Final Environmental Impact Report

GOLD LINE EASTSIDE TRANSIT CORRIDOR PHASE 2

April 2024

State Clearinghouse Number: 2010011062

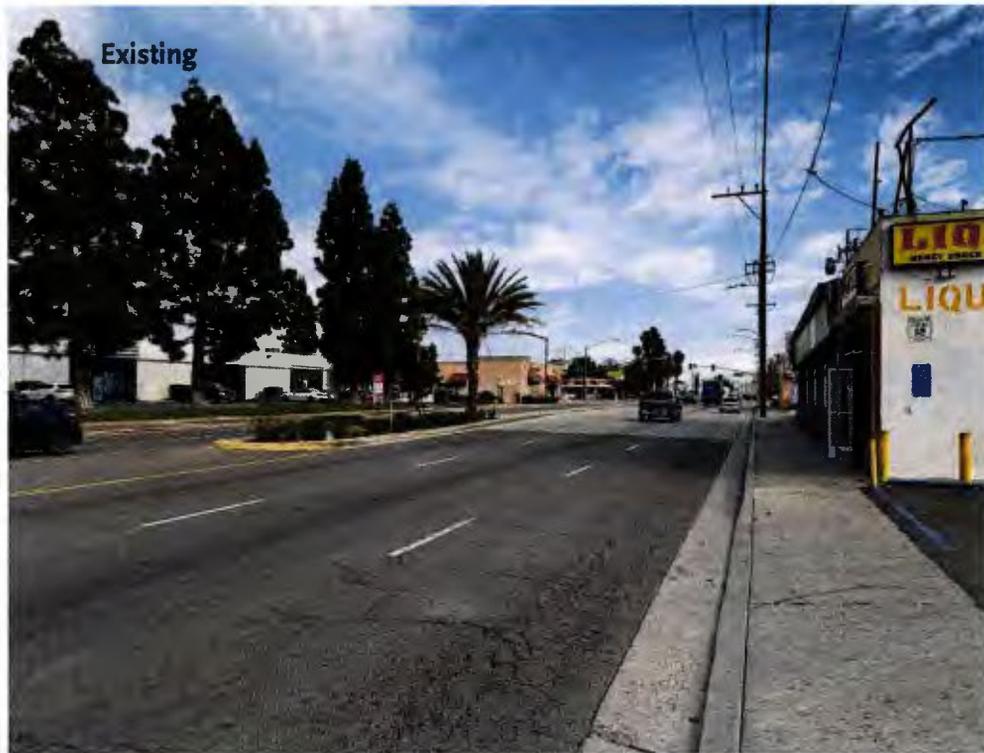
Page 36. The third paragraph of **Section 6.2.2**, Landscape Unit 2 – Smithway Street, Subsection Commerce, is hereby revised as follows in response to public comments received from the city of Commerce:

Page 78. **Figure 7.8**, "Visual Simulation: Washington Boulevard at Greenwood Avenue (At-Grade Option) (Looking east)" is hereby revised as follows to include a new Existing and Conceptual image to show the station consistent with the current Systemwide Station Design Standards Policy. The caption does not need to be updated.
